# Access Compliance Report

## Public Rights-of-Way

### (Curb Ramps)

Intersection ID: 16359	Main Street: FREELAND_LN	Cross Street: SOUTH_BV	Location: SW
ADA ID: 7AED0B64A01B	Ramp Type: Directional1	Initial Pass/Fail: Fail	Overall Compliance: No
			Severity Score: 13.75

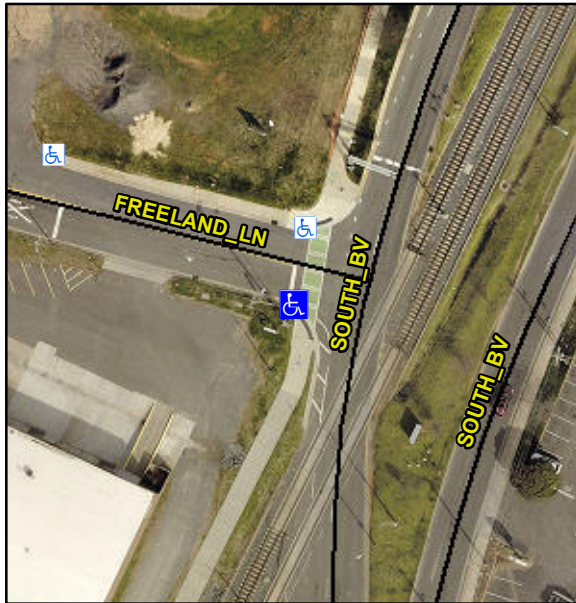
Possible Solutions:

**Remove & Replace Entire Ramp.**

PROW/ADA:

**R304.2.2, R304.5.3**

Compliance	Description	Data	Compliance	Description	Data
N/A	Ramp Length (in)	<b>62.0</b>	N/A	Grade Break?	<b>N/A</b>
Yes	Ramp Width (in)	<b>131.0</b>	N/A	Grade Break Slope (%)	<b>0.0</b>
No	Ramp Slope (%)	<b>9.3</b>	N/A	Grade Break XSlope (%)	<b>0.0</b>
No	Ramp XSlope (%)	<b>4.0</b>			
N/A	Flare Type LT	<b>N/A</b>	N/A	Flare Type RT	<b>N/A</b>
N/A	Flare Slope LT (%)	<b>N/A</b>	N/A	Flare Slope RT (%)	<b>0.0</b>
N/A	Flare Traversable LT?	<b>N/A</b>	N/A	Flare Traversable RT?	<b>N/A</b>
N/A	Landing Length (in)	<b>0.0</b>	N/A	DWS Provided?	<b>N/A</b>
N/A	Landing Width (in)	<b>0.0</b>	N/A	DWS Contrast?	<b>N/A</b>
N/A	Landing Slope (%)	<b>0.0</b>	N/A	DWS Length (in)	<b>N/A</b>
N/A	Landing X Slope (%)	<b>0.0</b>	N/A	DWS Full Width?	<b>N/A</b>
N/A	Landing Curb? (Y/N)	<b>N/A</b>	N/A	DWS Offset LT (in)	<b>N/A</b>
N/A	Shared Landing?	<b>N/A</b>	N/A	DWS Offset RT (in)	<b>N/A</b>
N/A	Gutter Ponding?	<b>0.0</b>	N/A	Gutter Slope (%)	<b>N/A</b>
